Addendum (ADD) #01

| Project: | 20-602: Marshfield Early Childhood Center |
| Client: | Marshfield R-I School District |
| Date: | June 15, 2021 |

A1-1 MARSHFIELD EARLY CHILDHOOD CENTER
FLOOR PLAN - AREA B
PROJECT NUMBER: 20-602
DATE: 2021.06.09
PROJECT DESCRIPTION: 600 N Locust St, Marshfield, MO 65706
BEE CS, KMW RKM, PY
PROJECT ARCHITECT: BEE CS, KMW RKM, PY
DRAWN BY: CS, KMW RKM, PY
CHECKED BY: RKM, PY

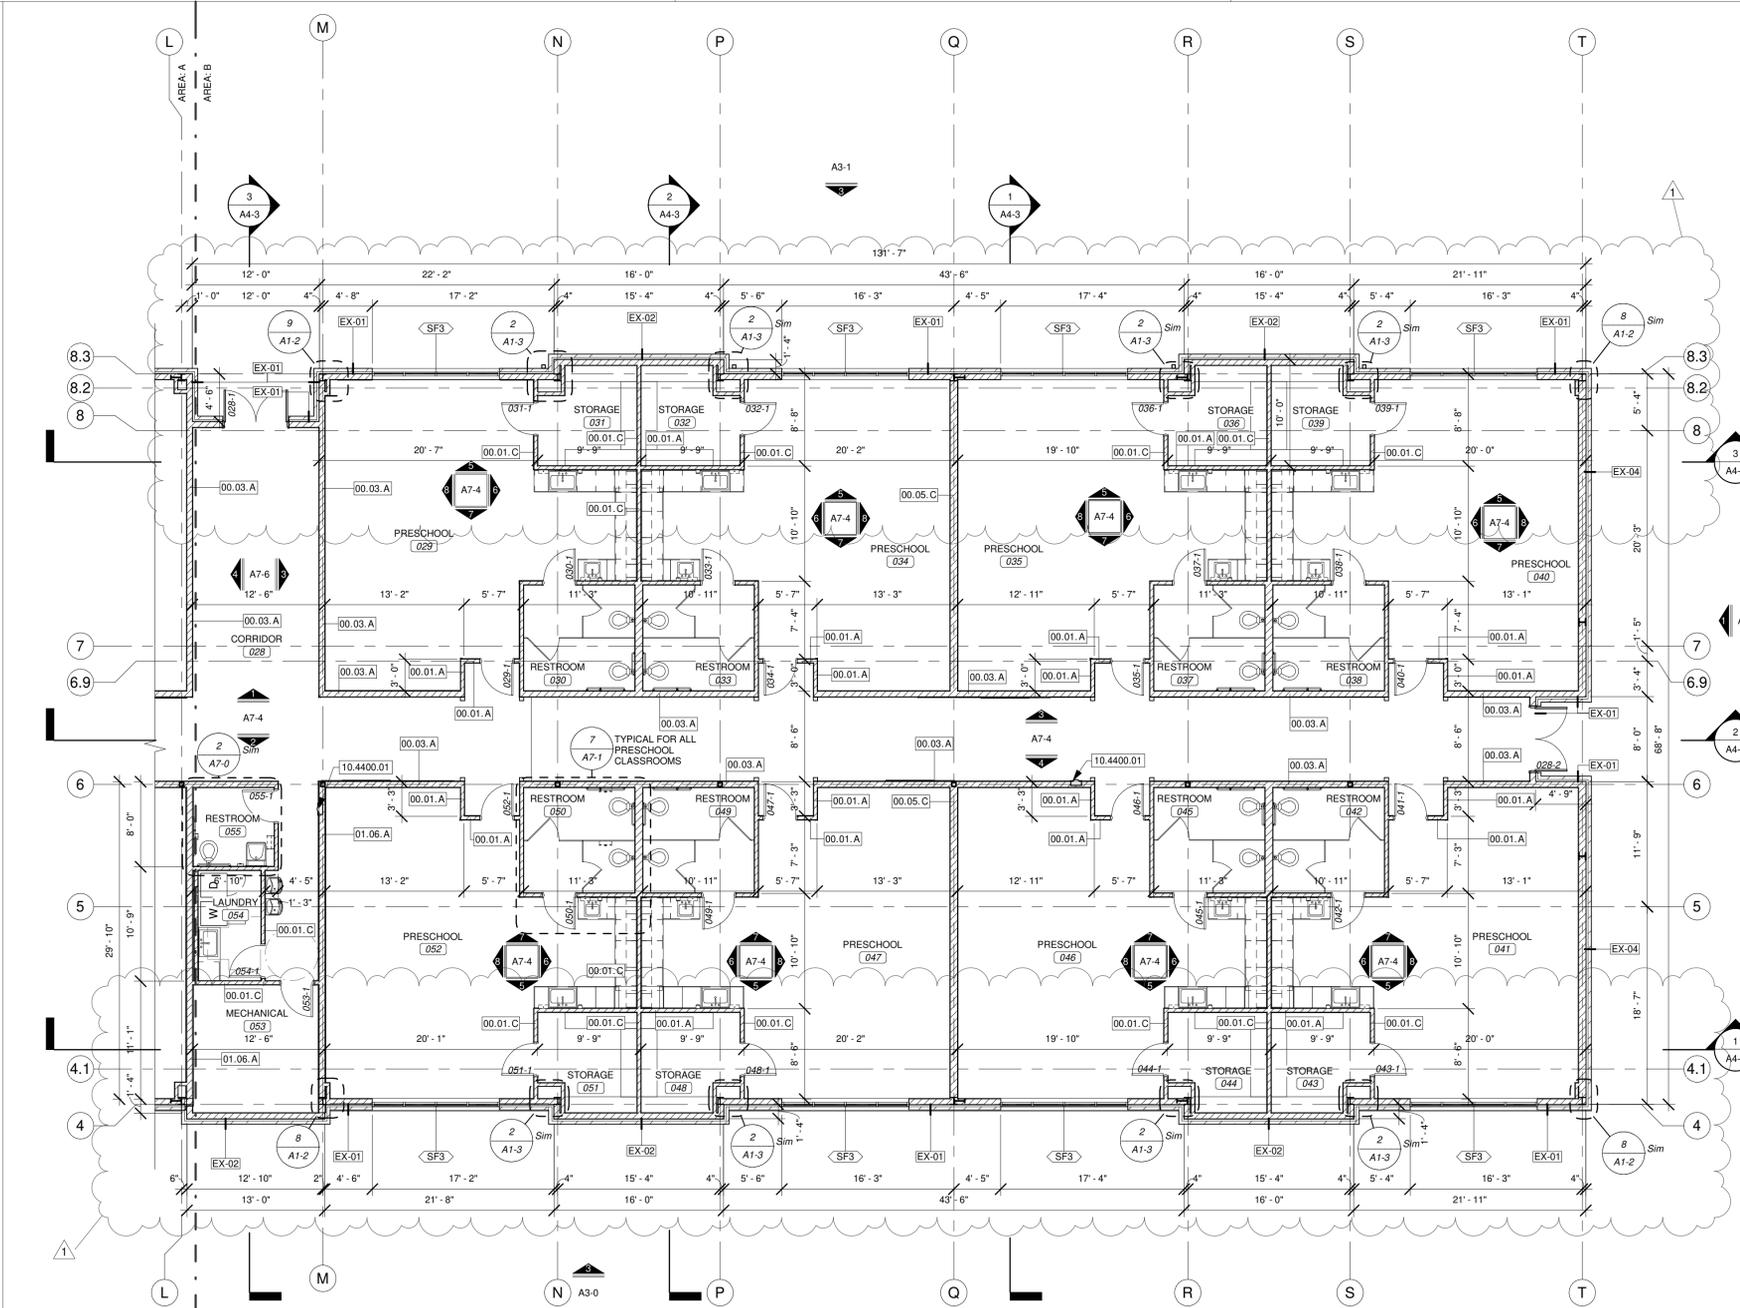
- i. Building footprint adjustments at Corridor 028 and Mechanical 053.
4. *Sheet A1-1 – Floor Plan – Area B:*
 - a. Revise, Detail 1
 - i. Building footprint adjustments at north exterior walls and south exterior walls.

PROJECT DESCRIPTION:
A2-0 MARSHFIELD EARLY CHILDHOOD CENTER
OVERALL ROOF PLAN
600 N Locust St, Marshfield, MO
PROJECT NUMBER:
20-602
DATE:
2021.06.09
PROJECT ARCHITECT: BEE
DRAWN BY: CS, KMW, DRW2
CHECKED BY: KMW, PY

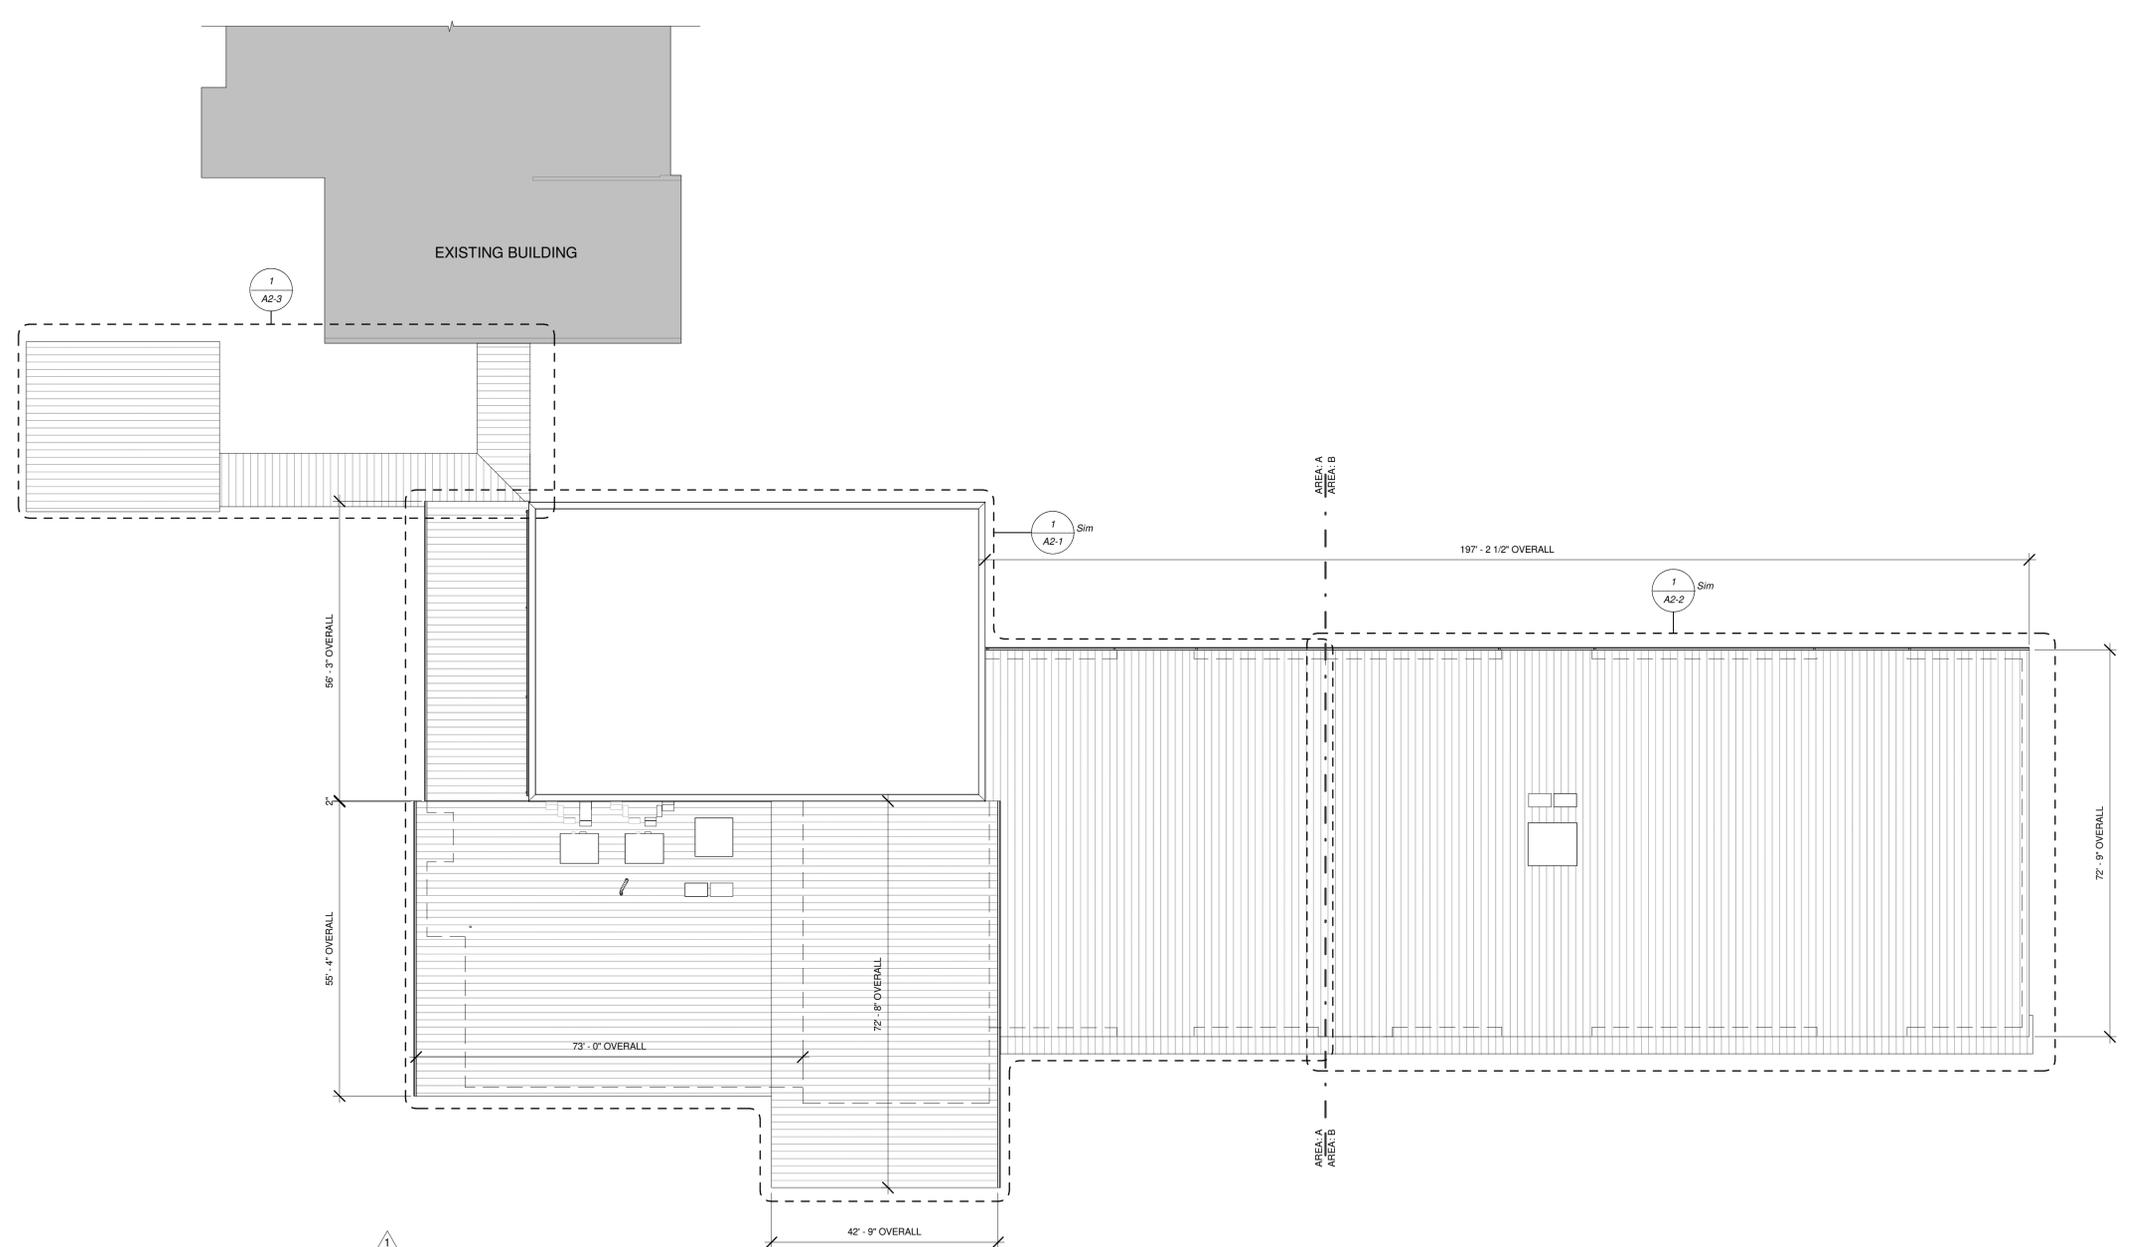
- a. Revise, Detail 1
 - i. Building overhang adjustments.
8. *Sheet A2-1 – Roof Plan – Area A:*
 - a. Revise, Detail 1
 - i. Building overhang adjustments.

A2-2 MARSHFIELD EARLY CHILDHOOD CENTER
ROOF PLAN - AREA B
PROJECT NUMBER: 20-602
DATE: 2021.06.09

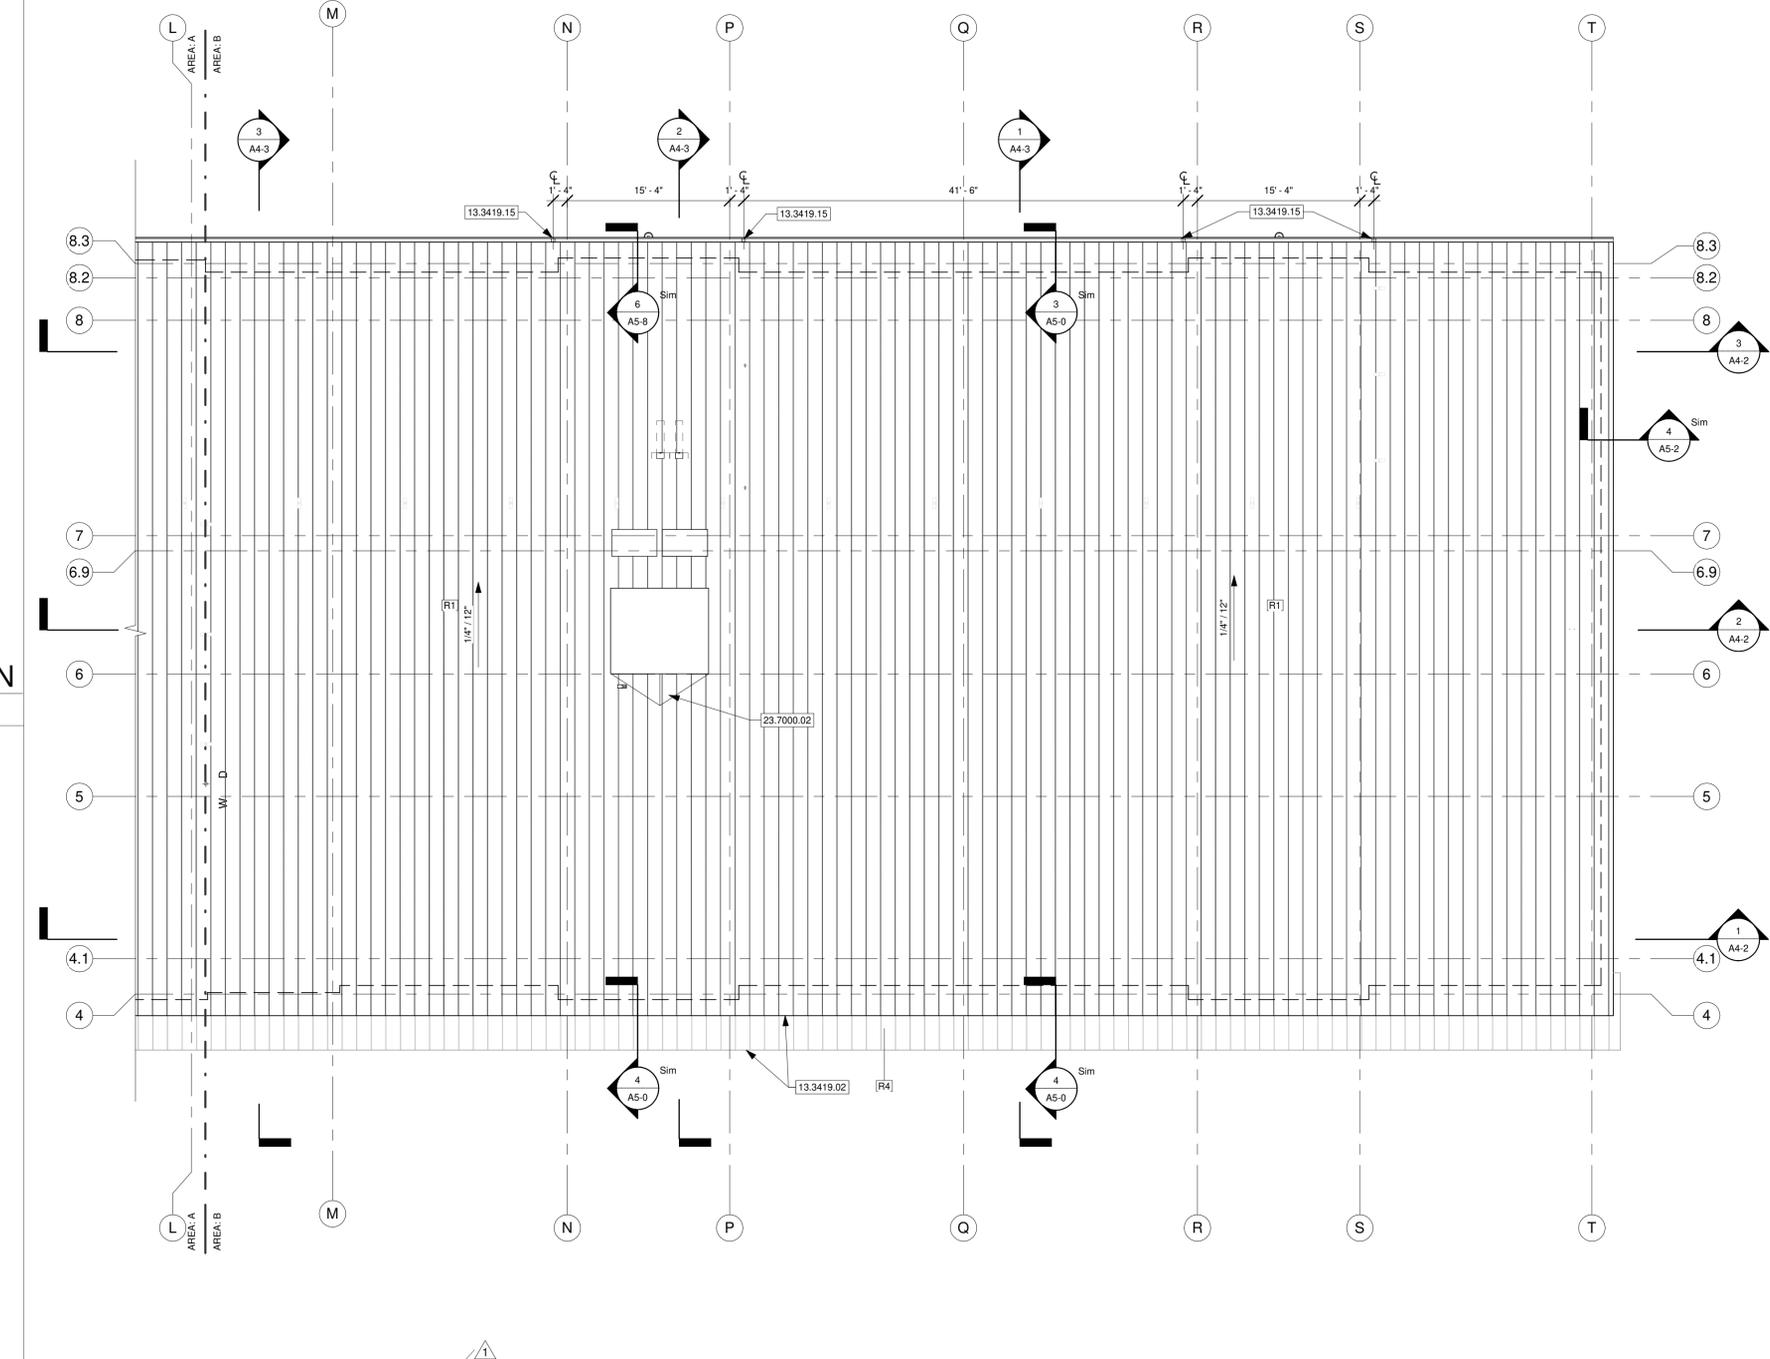
9. *Sheet A2-2 – Roof Plan – Area B:*
 - a. Revise, Detail 1
 - i. Building overhang adjustments.
10. *Sheet A5-7 – Details:*
 - a. Revise, Details 1 - 3
 - i. Details revised to reflect revised grid line placement and overhang dimensions.

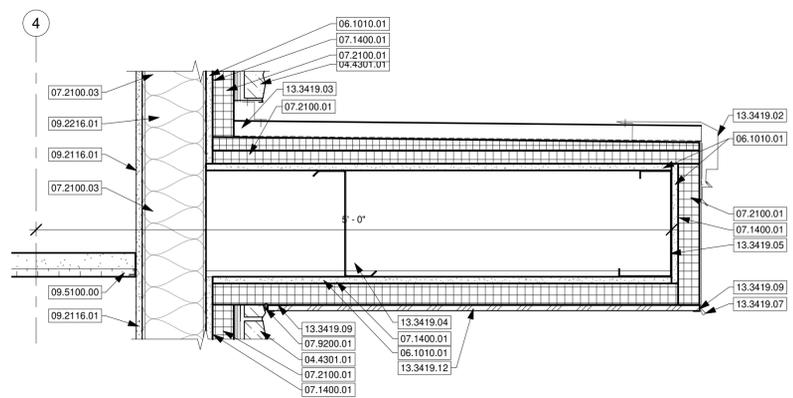
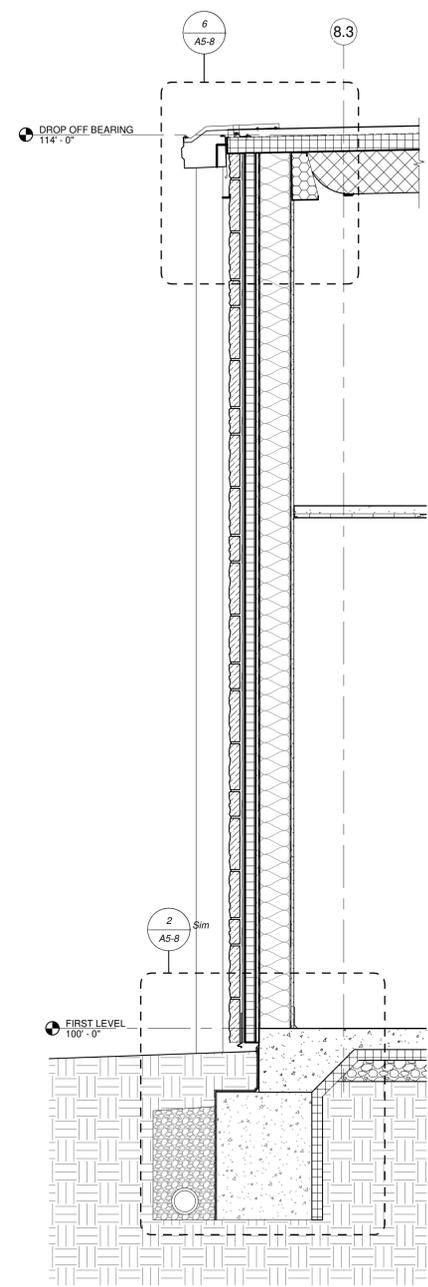
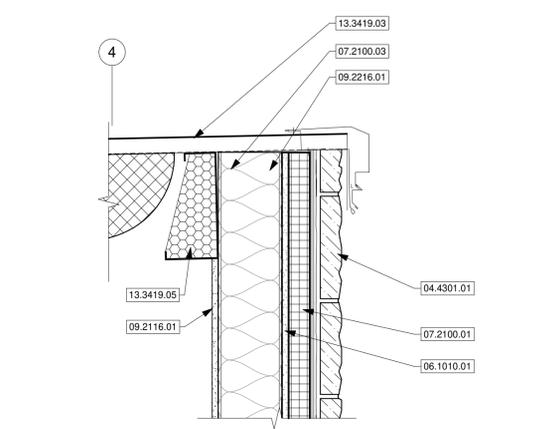
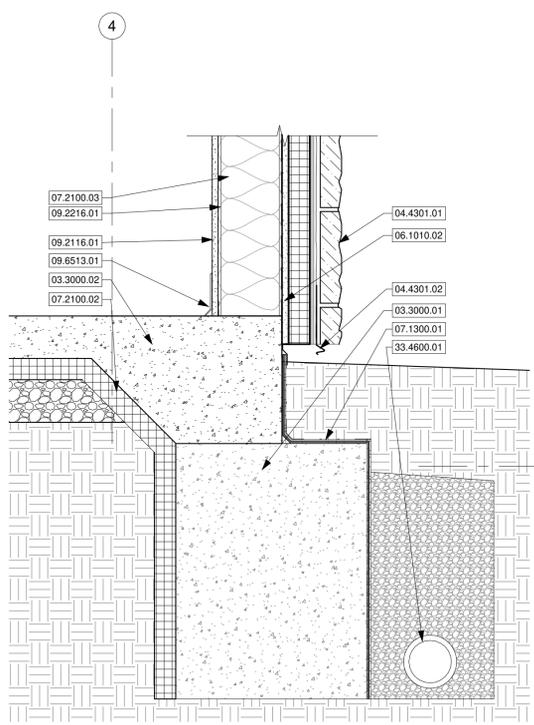
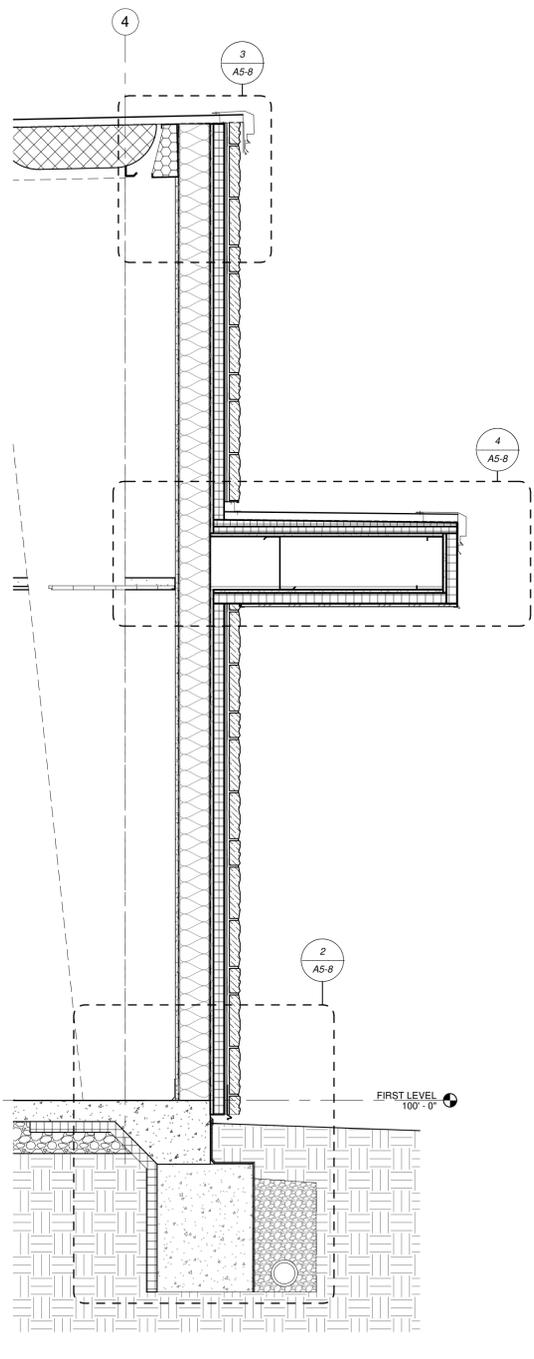
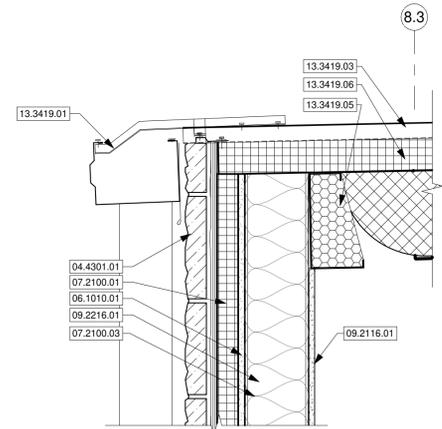
11. *Sheet A5-8 – Details:*
 - a. Revise, Details 1 - 6
 - i. Details revised to reflect revised grid line placement and overhang dimensions.
12. *Sheet A8-0 – Reflected Ceiling Plan – Area A:*
